MANGOOLA OPEN CUT

Re: Response to Questions from Applicant Meeting - Mangoola Coal Continued Operations Project (SSD-8642)

Figure 1 – Indicative MCCO Manning Levels (with and without the MCCO Project)

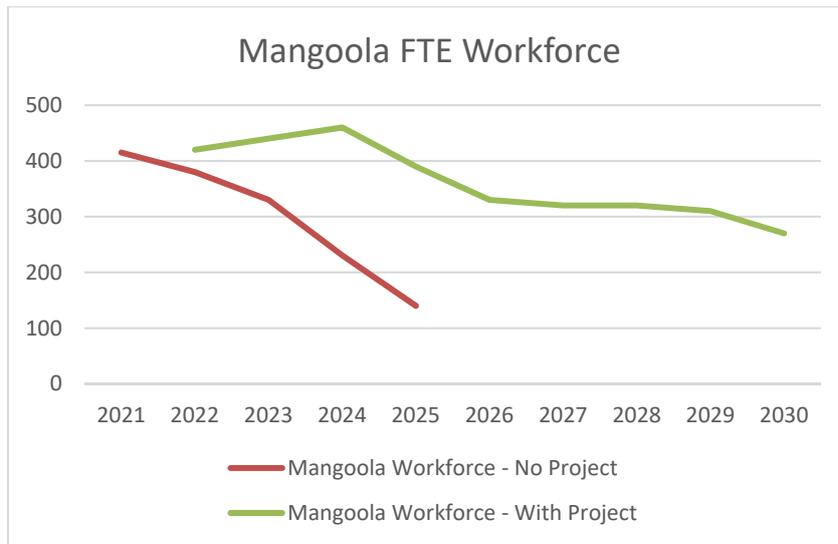
8. Can you provide details regarding numbers of people employed at Mangoola Mine since the mine commenced operations and the proposed workforce in annual FTE over the life of the mine?

Since the commencement of mining, Mangoola has provided direct full time employment for 717 individuals (excluding full time contract personnel) with varying years of service across the workforce.

The MCCO Project will provide ongoing employment opportunities for the Mangoola workforce of approximately 400 employees, rising to a peak of approximately 480 at peak production levels.

Mangoola reviews the life of mine plan and required workforce on an annual basis and may vary year to year dependant on operational needs. Consistent with the information contained within the EIS, **Figure 1** presents the current projected life of mine full time equivalent (FTE) workforce profile. This includes both with and without the Project. **Figure 2** shows the indicative production profile for the MCCO Project, over the corresponding period.
